Informal document No. WP.29-153-15  
(153<sup>rd</sup> WP.29, 8-11 March 2011  
agenda item 4.7.2.)

**Proposal for the 04 series of amendments  
to Regulation No. 10 (Electromagnetic compatibility)**

**OICA comments to ECE/TRANS/WP.29/2011/8**

### Annex 4, Appendix, Figure 3

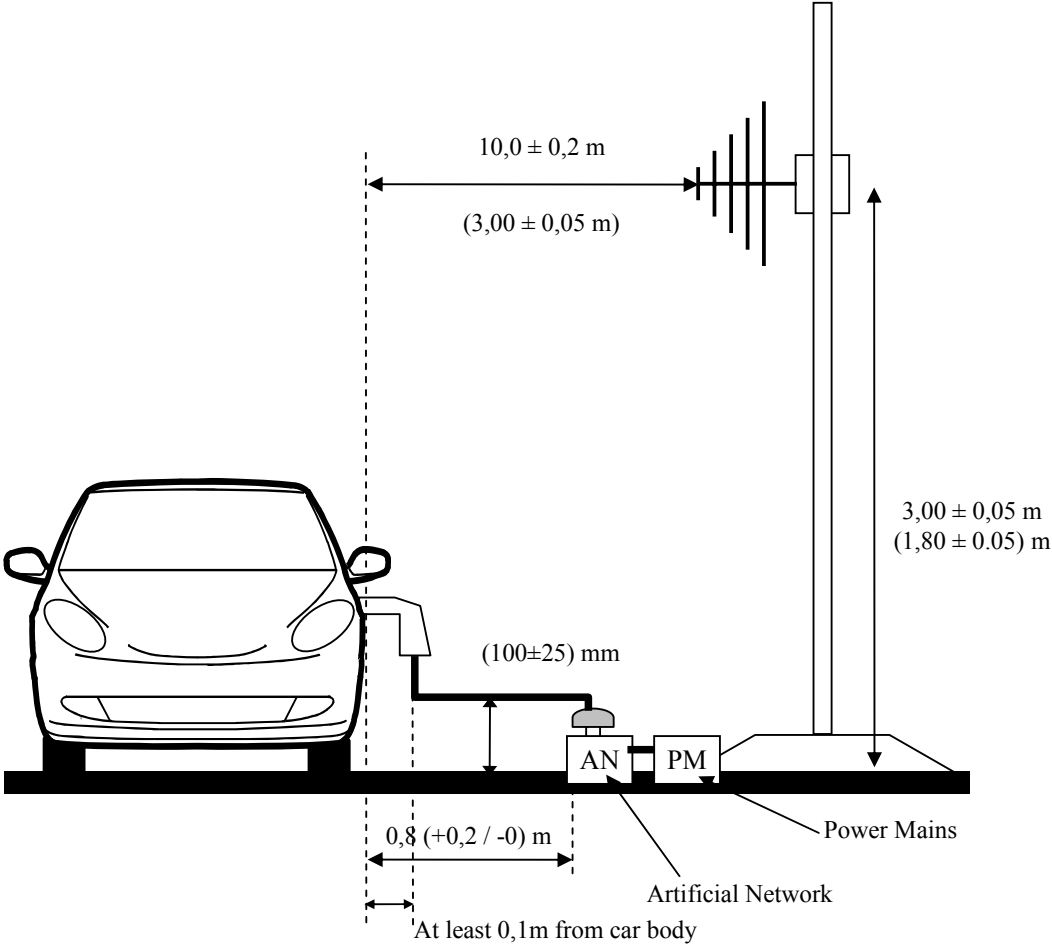
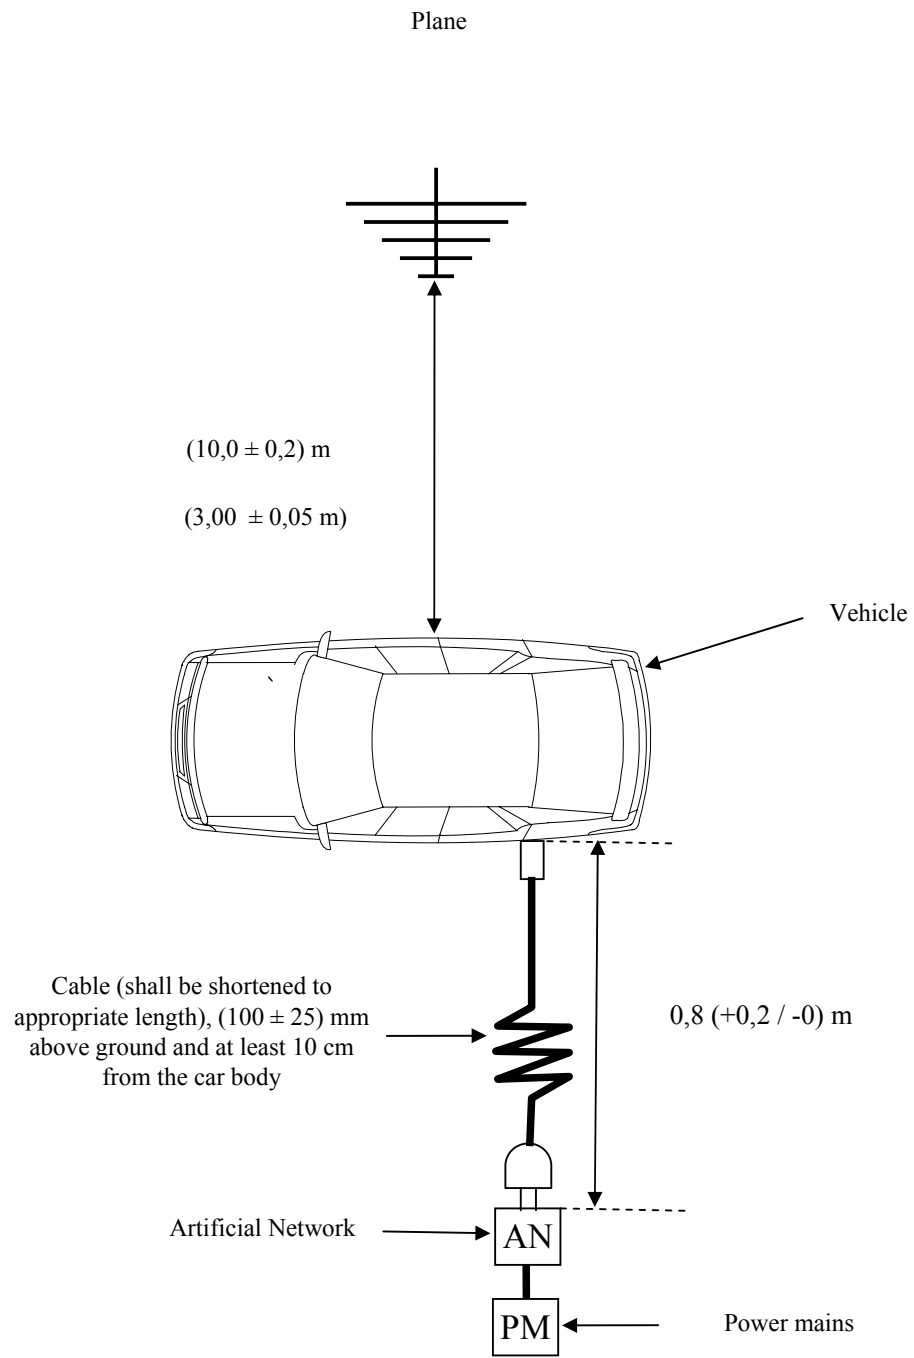
- Vertical dash line moved close to the vehicle side to clarify the distance requirements from the vehicle part (Figure 3, elevation)
- Replacement of “Cable (shall be shortened to appropriate length” by “Cable (shall be shortened to appropriate length), 100 ± 25 mm above ground and at least 10 cm from the car body” for consistency with elevation view (Figure 3, plane)
- Clarification of the 0,8 (+0,2 / -0) m distance requirement which applies between the vehicle and the AN (artificial network) and not between the vehicle and the AN and PM (power mains). The proposed clarification also concerns an additional dash line on vehicle side and a move of the PM

Replace figure 3 by the following:

### Annex 6, Appendix, Figure 4

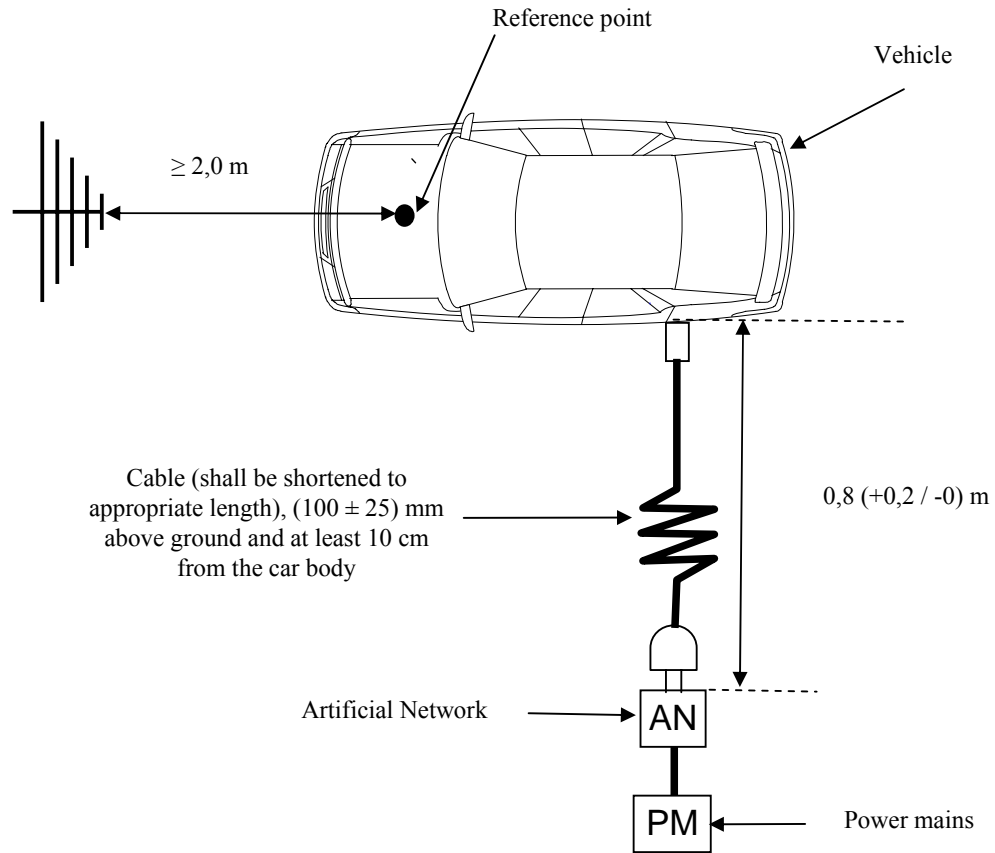
- Clarification of the 0,8 (+0,2 / -0) m distance requirement which applies between the vehicle and the AN (artificial network) and not between the vehicle and the AN and PM (power mains). The proposed clarification also concerns an additional dash line on vehicle side and a move of the PM square
- Additional dash point for reference point representation

Replace figure 4 by the following:

### Annex 13, Figure 1

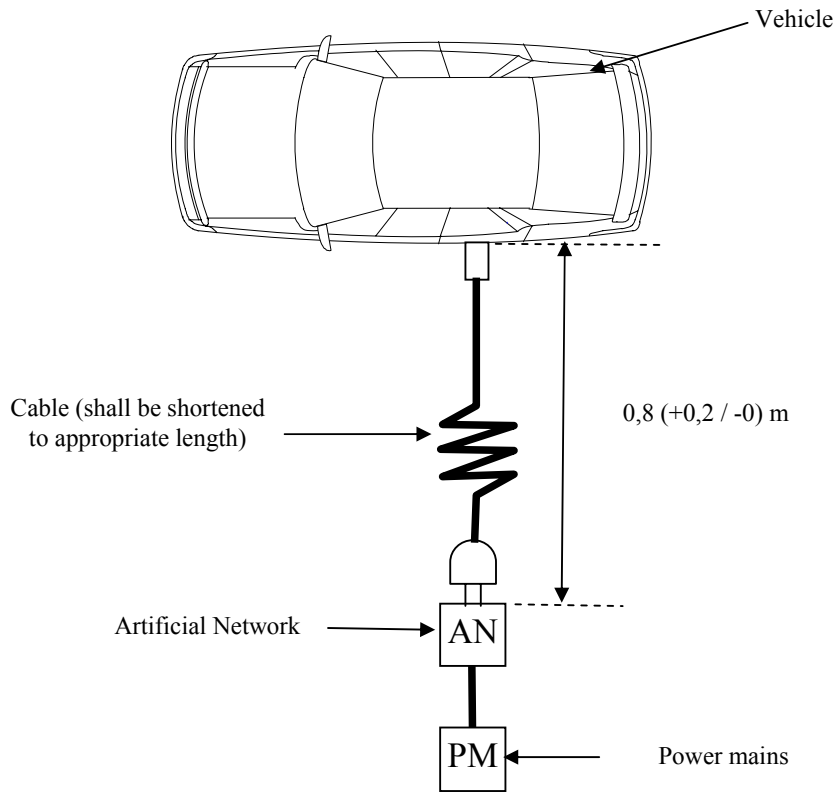
- Clarification of the 0,8 (+0,2 / -0) m distance requirement which applies between the vehicle and the AN (artificial network) and not between the vehicle and the AN and PM (power mains). The proposed clarification also concerns an additional dash line on vehicle side and a move of the PM square

Replace figure 1 by the following:

### Annex 14, Appendix 1, Figure 1

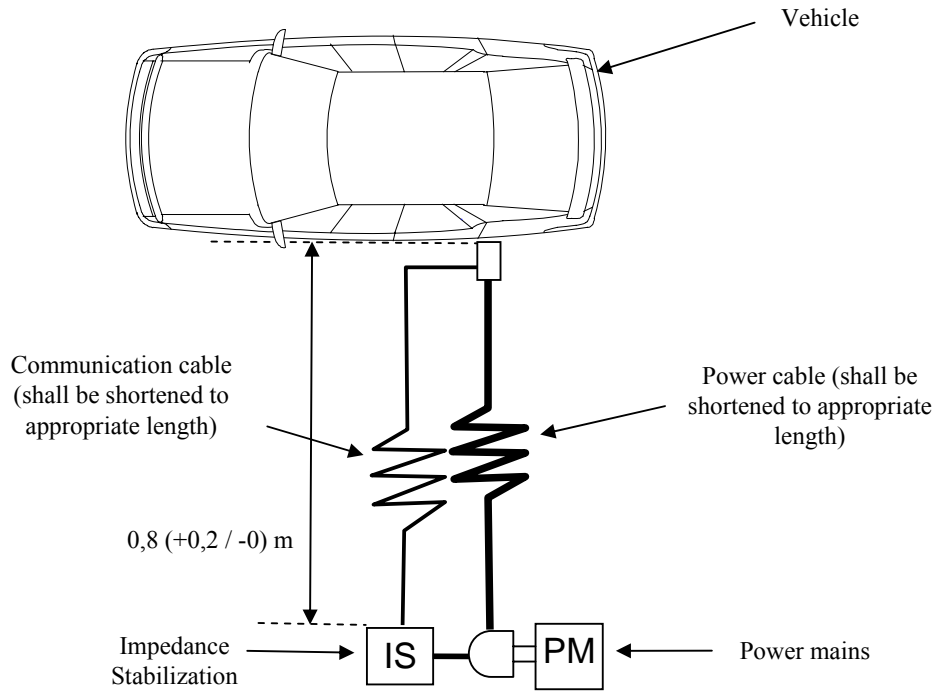
- Replacement of AN (artificial network) by IS (impedance stabilization) to be consistent with the wording used in Annex 14, paragraph 3.2.
- Additional dash line on vehicle side

Replace figure 1 by the following:
